MIDWEST POOLED FUND PROGRAM

Progress Report - Fourth Quarter 2010

Midwest Roadside Safety Facility
Nebraska Transportation Center
University of Nebraska-Lincoln

Figure 1. ADOT Long Span Details

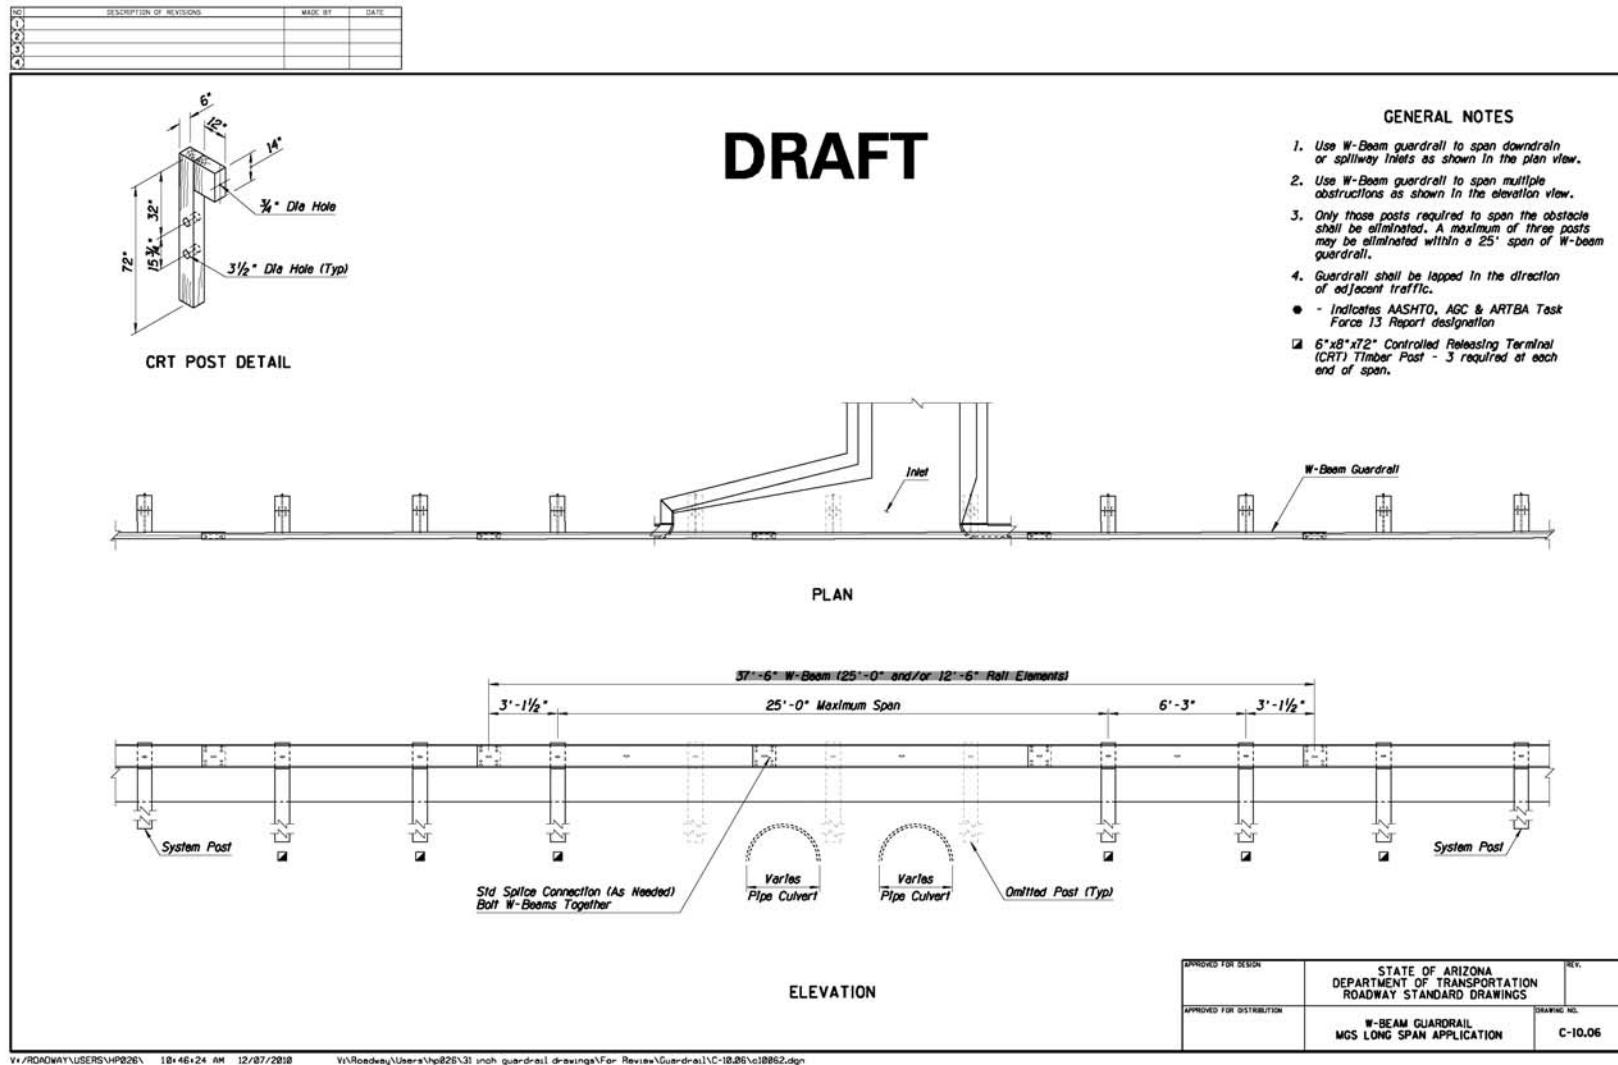
Ron - attached is our draft of the MGS Long Span Guardrail. We basically allow for one, two or three posts to be eliminated within the 25' maximum span. We call for the 3 CRT posts on each end when any posts are eliminated- would this still be prudent when only one or two posts are skipped? We also allow for 25' guardrail sections so the splice would be eliminated at midspan wherever it happens to fall in the guardrail run. We assume this also applies to the normal MGS guardrail runs when 25' rail elements are used. We would appreciate if you could take a look and provide any comments you feel appropriate.

When one, two, or three posts are removed in a row of MGS, MwRSF still recommends that three MGS CRT posts be utilized on the upstream and downstream sides of the 12.5 ft, 18.75 ft, and 25 ft unsupported lengths. The span could be accommodated with 25 ft long guardrail segments where the rail splice does not occur at the post locations. The CRT posts were modified for MGS Long-Span applications by raising the hole locations to account for higher rail heights. For metric-height guardrail, different CRT posts were used for long-span applications. As such, CRT posts for the MGS long-span uses different hole locations than those placed in the CRT posts for metric-height W-beam long-span applications. It may have been more clear if we had referred to the posts as MGS CRT posts or 31" guardrail CRT posts. As long as you provide dimensions, it should not be an issue. You might consider showing the two holes in the six posts adjacent to the long span in PLAN and ELEVATION views.

As a minor point, the guardrail posts appear to be square in the PLAN view. Also, there are some extra dashed lines in PLAN view across vertical surface between post and blockout – not sure if those are nails or something else. May also want to add barrier height to ELEVATION view.

Figure 5. INDOT PCB Details

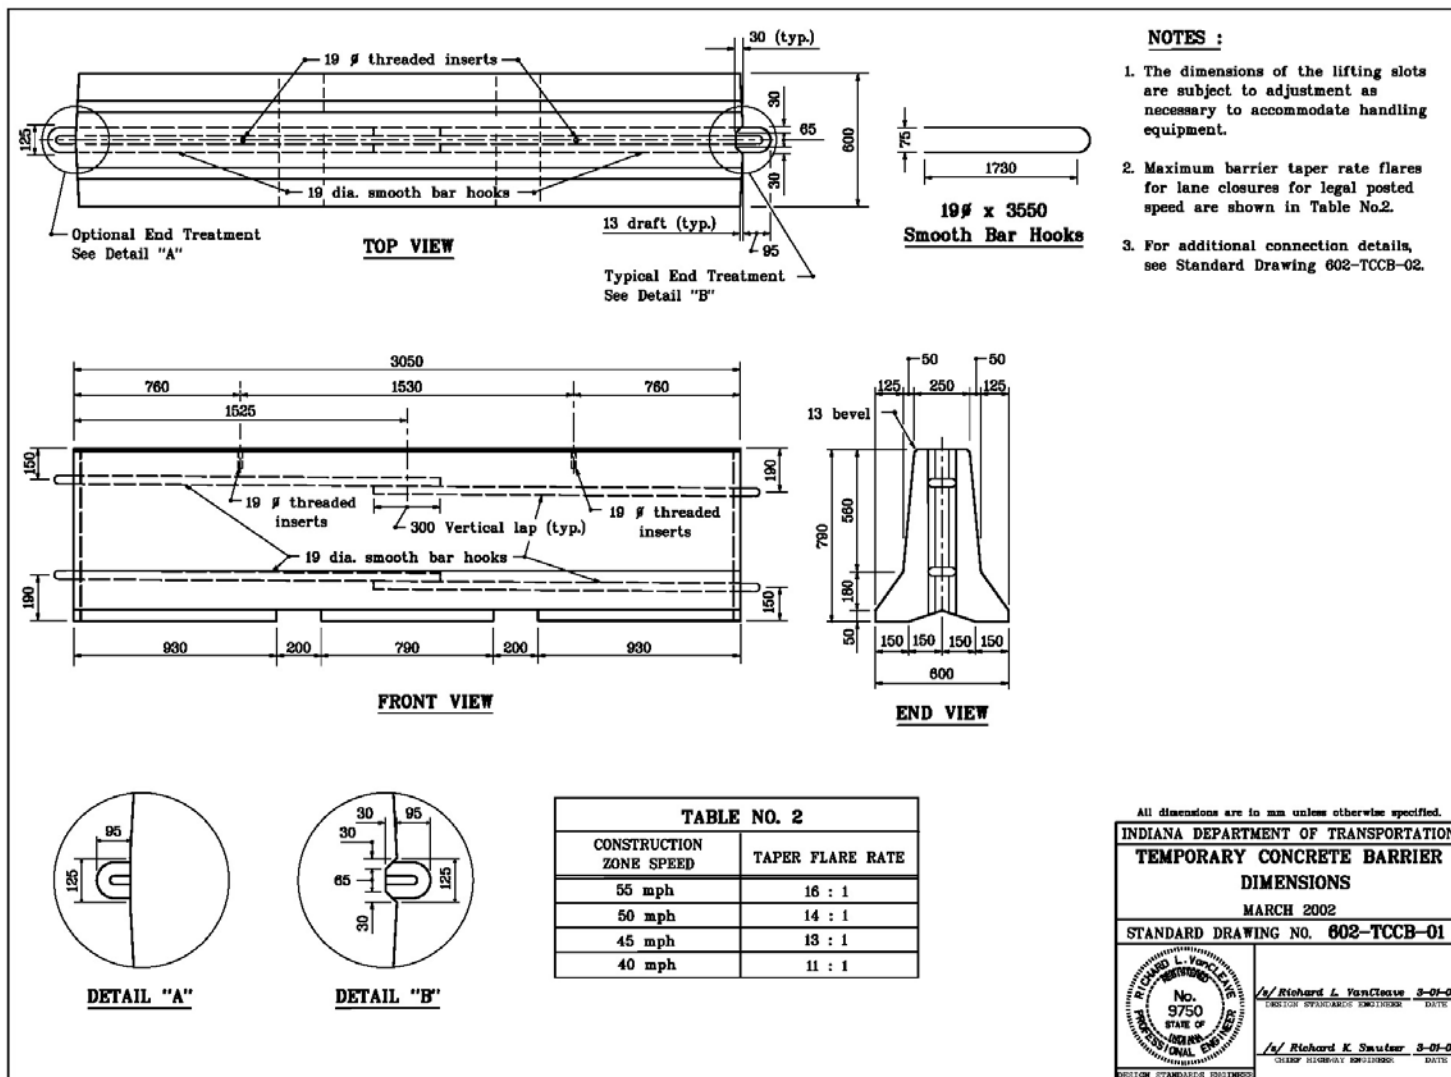
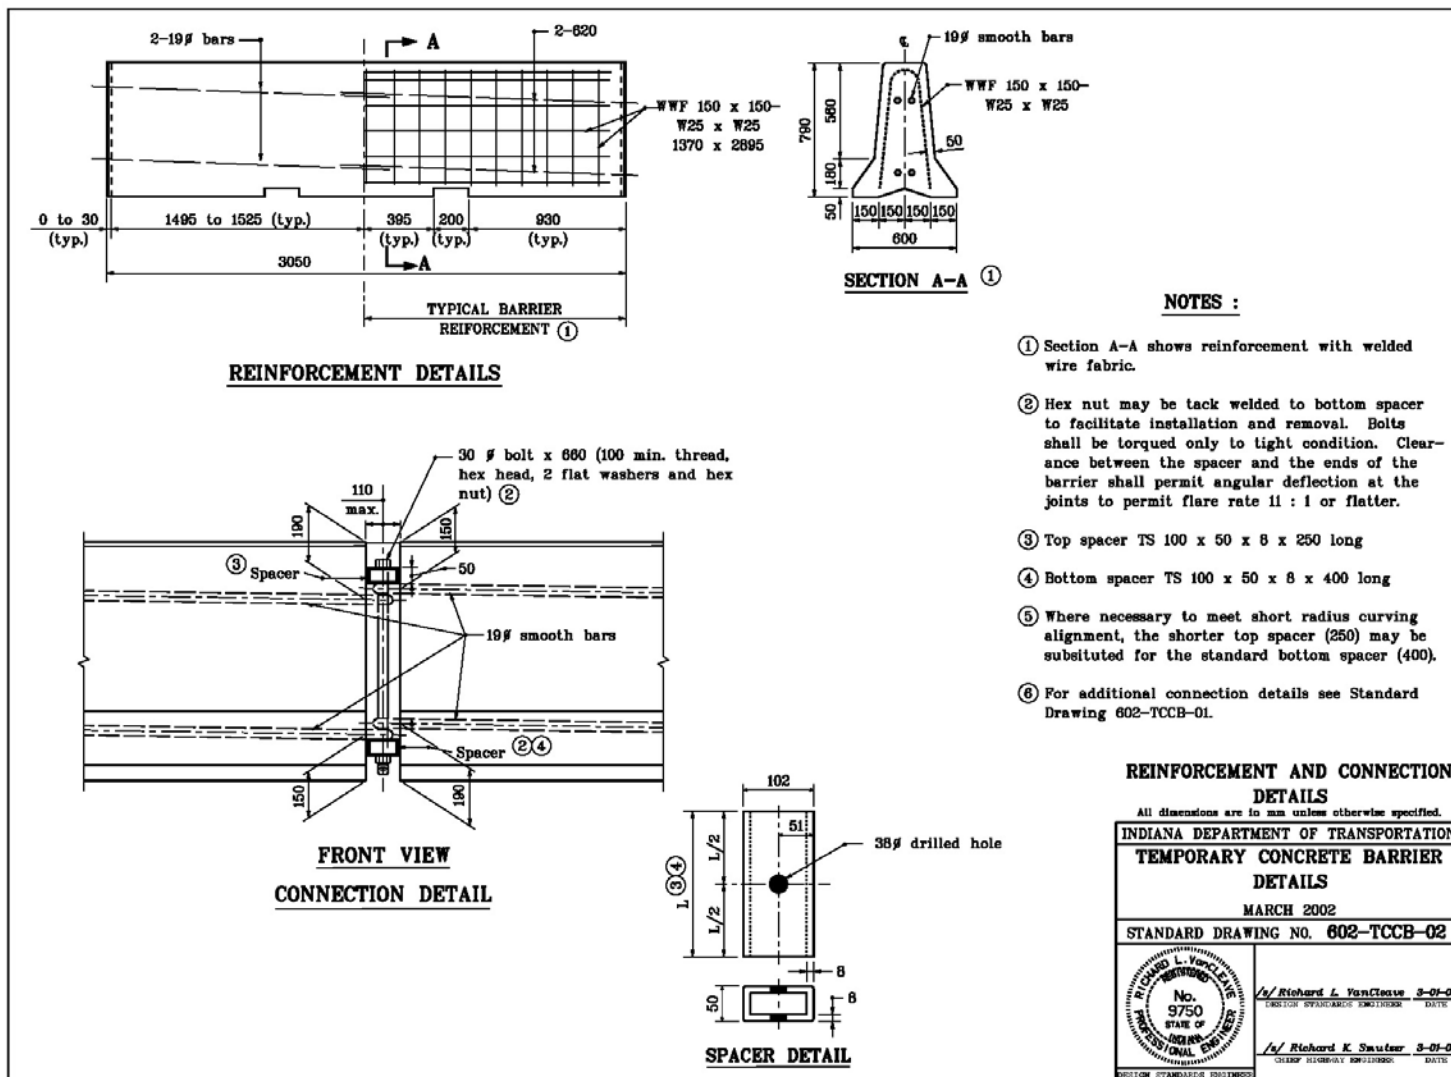
In the meantime, please review and provide any comments you have concerning our approach.

1. The Indiana barrier would need to be modified to accommodate the anchor holes and additional reinforcement for the anchors holes present in the MwRSF design.

3. The Indiana barrier would need to be modified to have equal or greater barrier reinforcement throughout the barrier as the MwRSF design. Our testing of these barrier in their anchored configuration has shown that we are very close to the capacity of the barrier section we have. We would also like to see the shear steel extended into the toe of the barrier in a manner similar to the MwRSF design.

Figure 7. Modified INDOT PCB Details

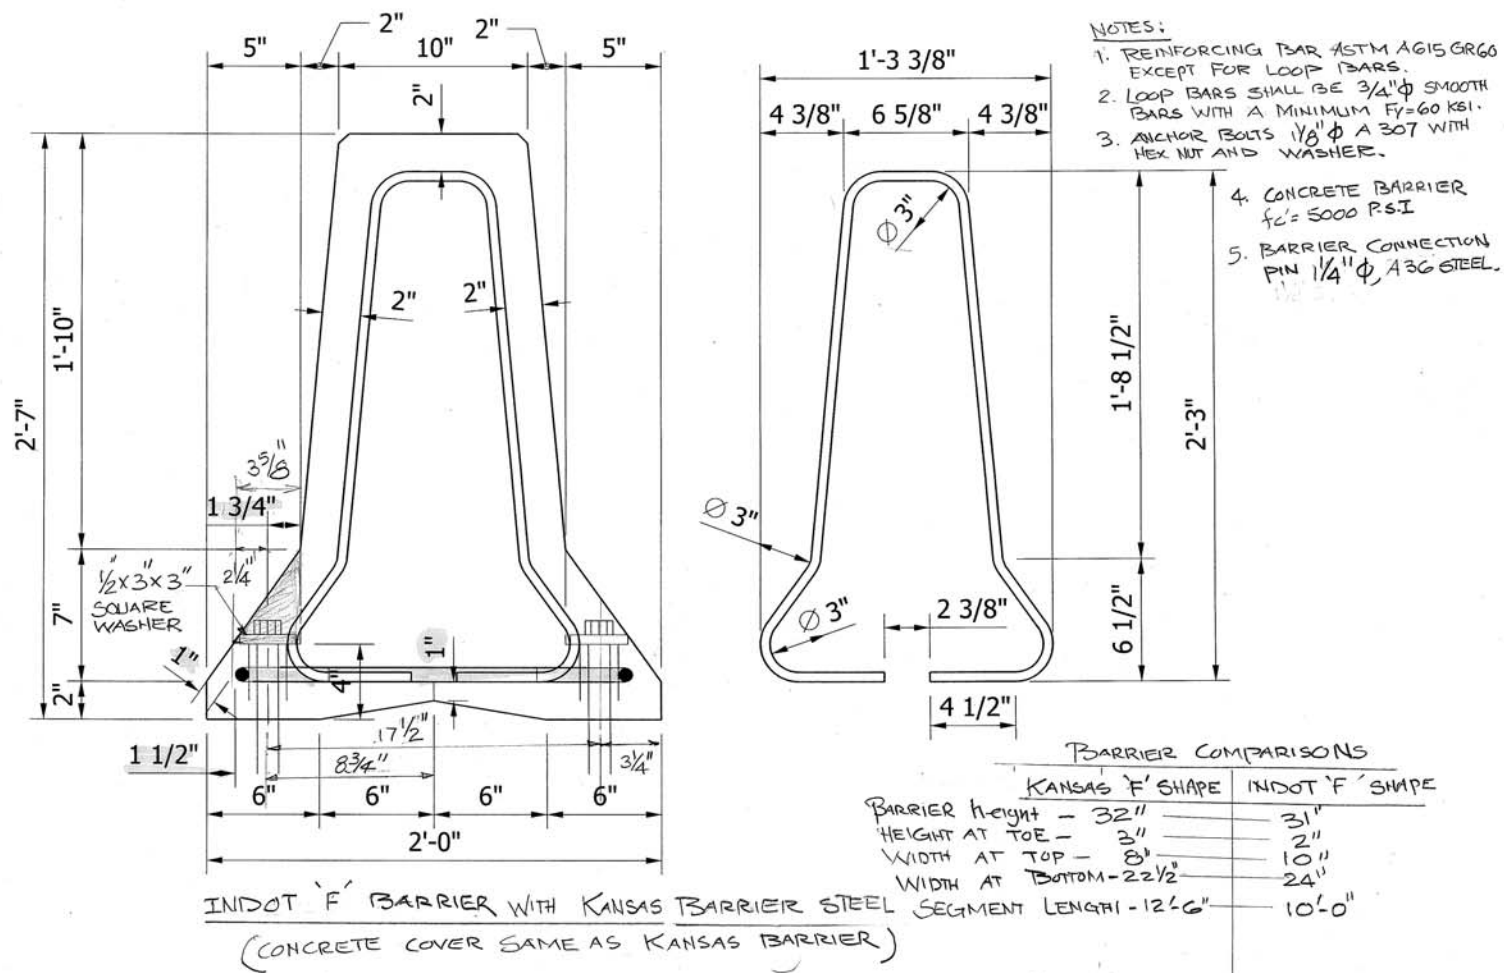
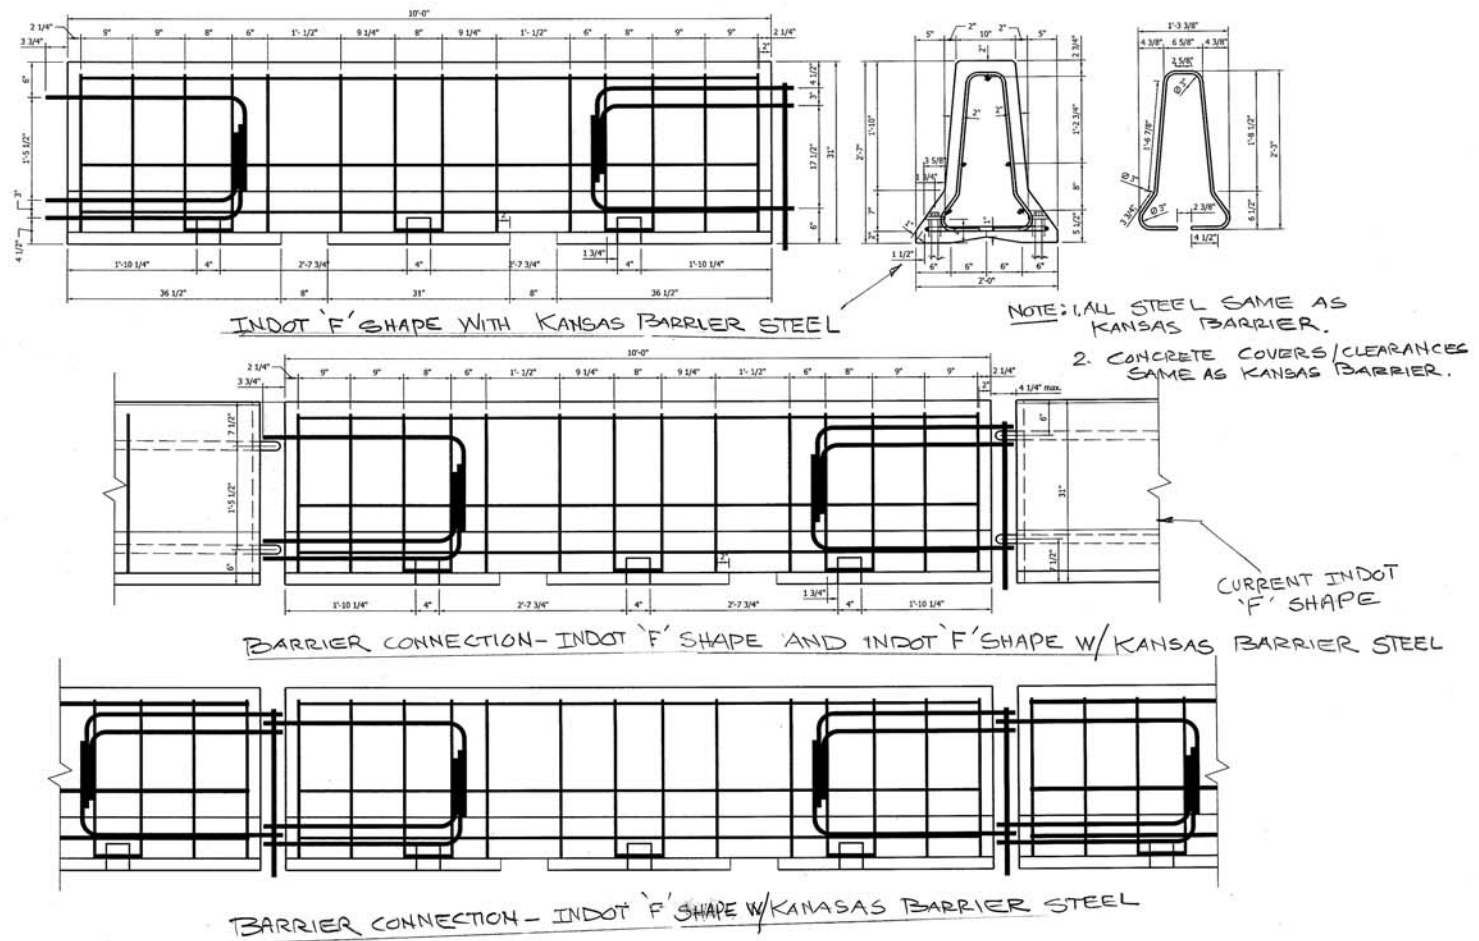
Attached preliminary drawings show modified INDOT F-shape TCB with Kansas F-shape TCB reinforcing bars and anchor bolt details.

1. The drawing sheet I of 2 shows modified shape of the INDOT TCB to accommodate the anchor holes and additional reinforcement for the anchor holes same as Kansas barrier. The drawing also shows the comparisons between the two barrier shapes and the barrier steel and concrete strength details which are same as Kansas barrier. Note that INDOT barrier toe is 2" but has same concrete cover and clearances as Kansas barrier.

2. The Indiana barrier is 2'-6" shorter than Kansas barrier but will have same number of anchor points (anchor bolts on traffic side only).
3. Indiana Barrier will have equal barrier reinforcement similar to the Kansas barrier but closely spaced due to the shorter length of the Indiana barrier as shown on sheet 2 of 2 of the attached drawing.

4. The sheet 2 of 2 of the drawing shows six loops design as you have recommended.
5. The connection pin between barriers will be 1 1/4" diameter, A36 steel minimum.

Please review these modifications to the Indiana F-shape anchored barrier and provide your feedback and let us know if this anchored barrier can be qualified and approved to NCHRP 350, TL3 without test. We are planning to prepare final drawings of the Indiana modified barrier after we hear from you. We will send you the final drawings again for your review.

1. You list loop bars as 3/4" diameter smooth bars with $F_y = 60$ ksi. This is not the correct spec. The proper spec for the loop bar steel is, "The loop bars (6d1, 6d2, and 6d3) shall be A706 Grade 60 or A709 Grade 70 0.75" [19] smooth or deformed steel bars. Alternative steel chemistry may be used as long as the alternative material provides a minimum yield of 60 ksi [420 MPa], a tensile strength of not less than 1.25 times the yield strength but a minimum of 78 ksi [550 MPa], a minimum 14% elongation in 8" [203], and passing a 180 degree bend test using a 3.5D pin bend diameter. The loops shall be installed within 0.12" [3] of the plan dimensions."

4. On one of your details, you show the three loop connection attached to your current F-shape barrier with two loops. While we believe that this type of connection can work, we would only recommend mixing barrier segments in free-standing barrier installations. Also, when connecting barriers with dissimilar loop connections, we would recommend that a 1/2" dia. x 10" Grade 5 Hex bolt and 2.5"x4"x1/2" keeper plate be used at the bottom of the connection pin to insure the pin does not pull out of the loops under load. This bolt and keeper plate were part of the original barrier connection, but were eliminated after switching to the 3 loop connection. However, if you connect the three loop connection to your current F-shape barrier with two loops, we would recommend that the bolt and keeper plate be used.

Figure 10. SD Snow Gate – Proposed Modifications

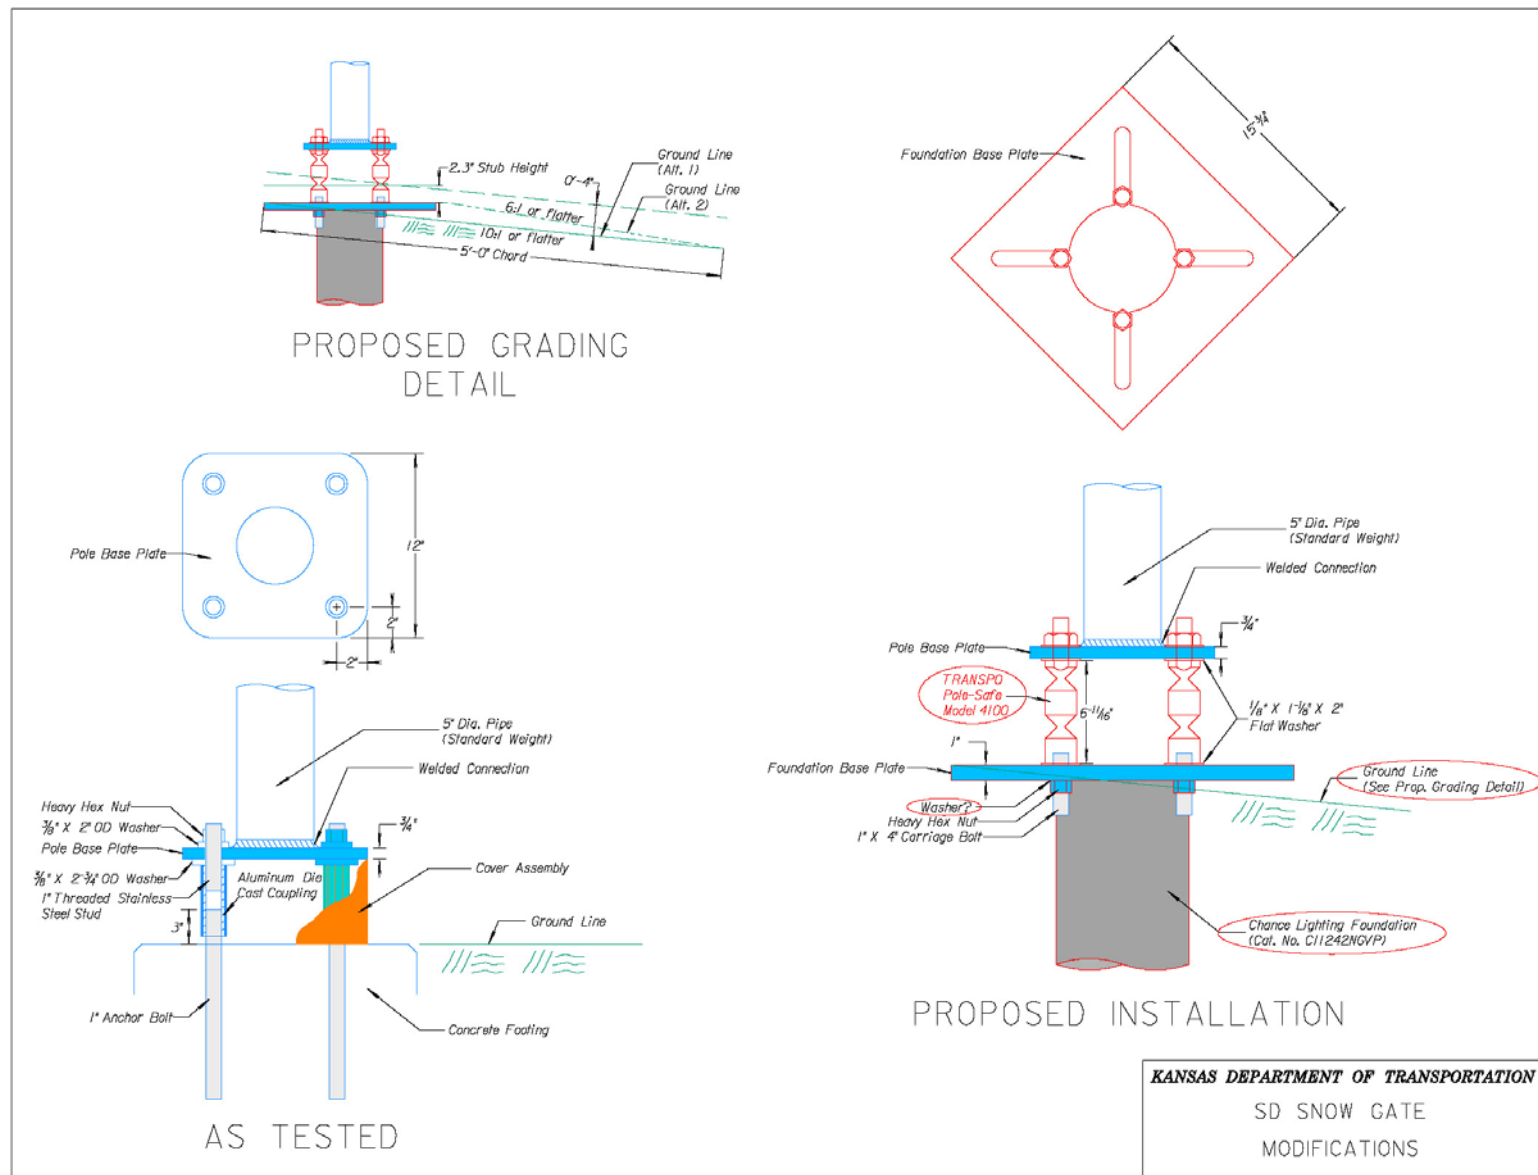
Our district staff would like to install a modified version of the South Dakota snow gate (See attached “SD Snow Gate.pdf” and “TRP-03-44-94.pdf”). However, they are proposing some modifications to the base:

Would you please review the attached “SD_SnowGate_Mod.pdf” and verify that these modifications will not affect the crashworthiness of the system? Please comment also on the grading as shown. (Sorry for the short notice).

1. Coupler equivalency - You are proposing to change from the Pole-Safer 201 couplers that were used in the tested design to the Pole-Safe 4100 design. In order to replace the couplers from the original tested design, we need to verify that the Pole-Safe 4100 couplers perform in a similar manner and would break away without increasing the occupant risk limits of the design. I have looked up the approval letters for both coupler designs, but they do not contain sufficient information to evaluate the couplers. As such, we would recommend that you contact Transpo for guidance on the replacement of the coupler. If they can show that the coupler design would work similar to the Pole-Safe 201 for a short, heavy break away device, then use of the Pole-Safe 4100 would be acceptable.

It appears that Transpo has stated that the Polesafe 4100 and 201 models have equivalent breakaway loads. Thus, it would be acceptable to use the 4100 model in your modified design. The only way to further evaluate this would be to compare the velocity change for tests of short, heavy poles from testing of both the 201 and 4100 couplers.
